RESPONSE TO SUBMISSIONS

ANGUS PLACE COLLIERY

Angus Place Mine Extension Project

State Significant Development 5602

Figure 1 - Monitoring Bore Transect

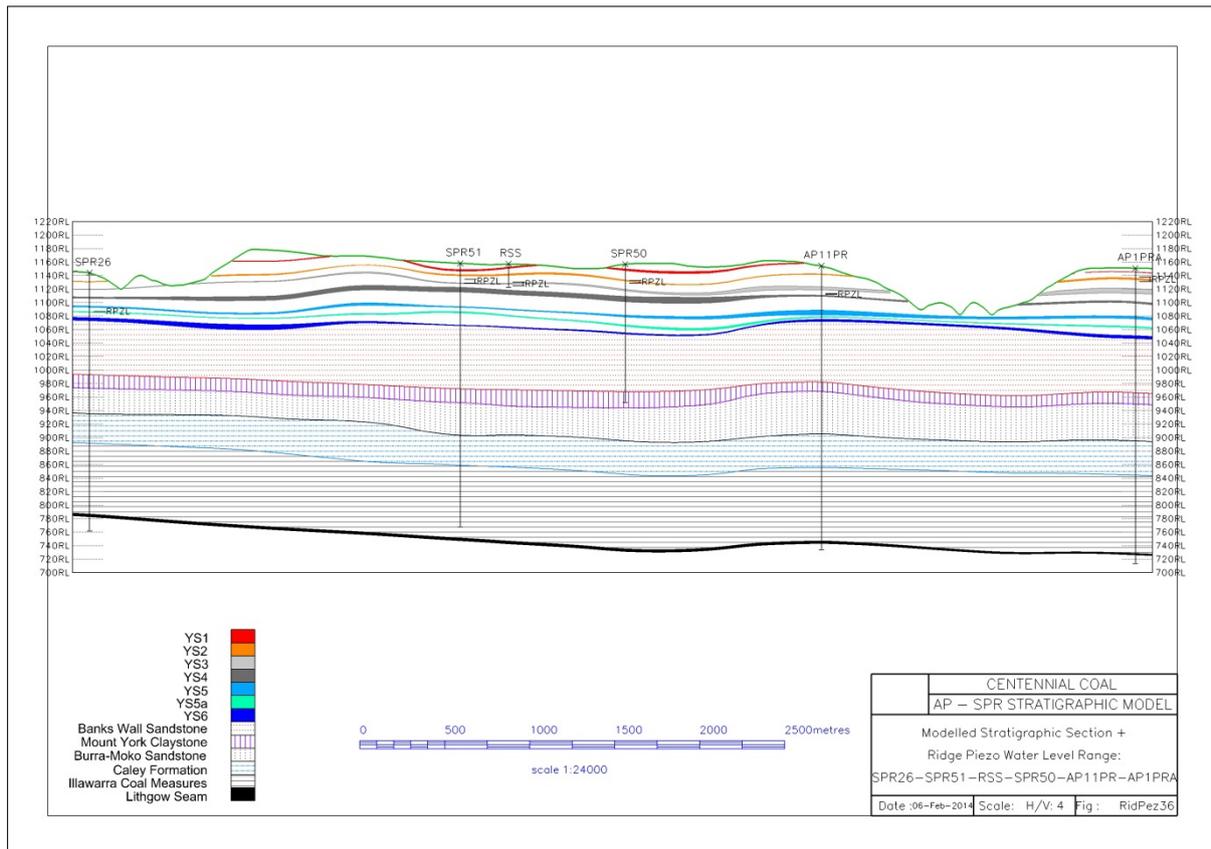
The close proximity of instruments in the piezometer network has been used in conjunction with a three dimensional topographic and stratigraphic model to enable an understanding of groundwater levels and their interaction with swamps. **Figure 1** below shows a cross section of topography, stratigraphy, groundwater levels along a transect between a number of monitoring bores. EIS Section 2.6.2.6 Figures 2.24 to 2.26 shows a similar transect between ridge piezometer bores installed in 2005.

The nearest Longwall to the Wolgan River is LW1002 at 240m. LW1019 will be 400m from Carne Creek. The predicted subsidence and tilting of these watercourses are not expected to result in any stream bed cracking or loss of surface waters. The proposed monitoring will rely on upstream and downstream monitoring on these two watercourses. Pool depth monitoring of the key pools in the watercourses should also be undertaken to confirm these predictions. (DRE).

Figure 5 - Coal Mine Roof Rating Versus Depth of Cover

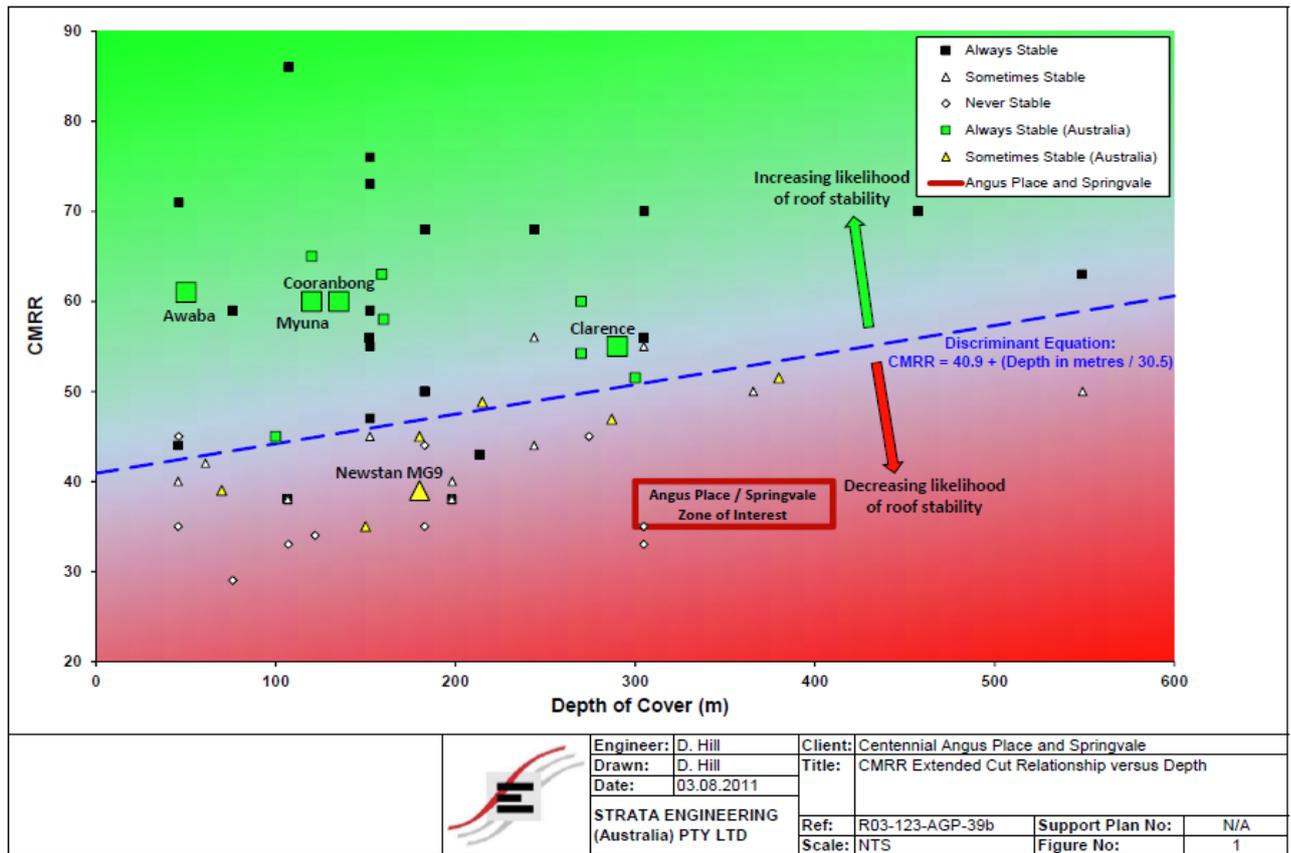
Figure 5 is a graph of 18 Australian case studies and 44 case studies from the US database. The dashed blue line is the discriminant equation, which is the relationship that best separates the 'always stable' from the 'sometimes' and 'never stable' cases. The Australian 'always stable' cases are generally characterised by CMRRs of >50 and depths of \leq 300m. The Springvale data is expressed as a regime defined by the CMRR range of 35 to 40 and a depth range of 300m to 400m (i.e. within the red box in the figure).

Strata Engineering (2010) stated: “With regard to the Angus Place / Springvale ‘regime’, the data all lies below the discriminant equation line, with adverse implications for the stability of extended cut stability. The available precedents suggest that failure is almost certain at a depth of >200 m.”

Figure 6 - Layout of the Water Quality model at Kangaroo Creek.

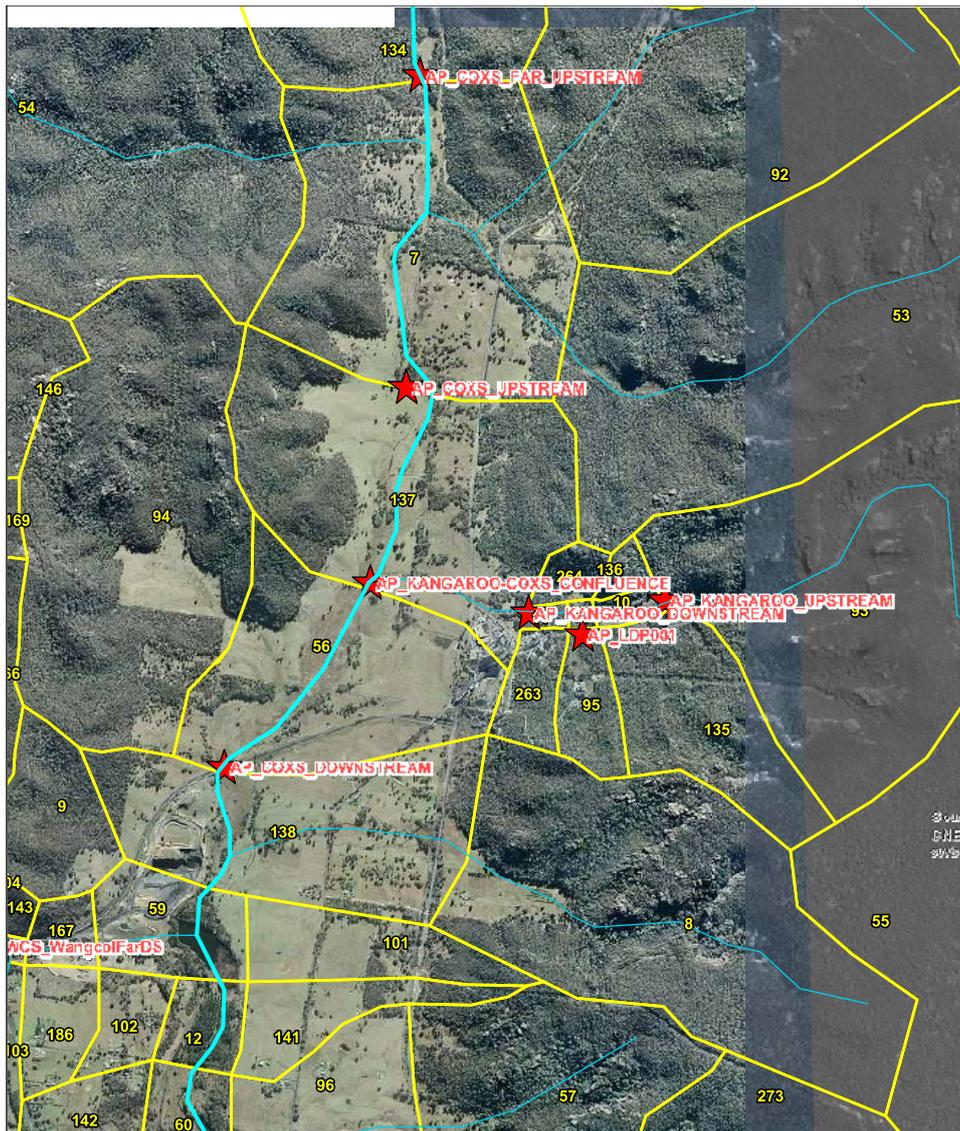
The baseflow reductions in Kangaroo Creek are inconsistently presented in the EIS (pages 74 and 75 of Appendix E). Figures 55 and 57 presenting baseflow predictions either do not show Kangaroo Creek or Kangaroo Creek has not been labelled clearly. (SCA)

The layout of the water quality model in this vicinity is presented below (**Figure 6**) and show the relevant sub-catchments modelled.

Water quality modelling indicates that historical discharge at Angus Place LDP001 accounts for observed increase in salinity in Kangaroo Creek and the Upper Coxs River above Blue Lagoon. The calibration simulation is presented below at monitoring station AP_KANGAROO_DOWNSTREAM (#011).
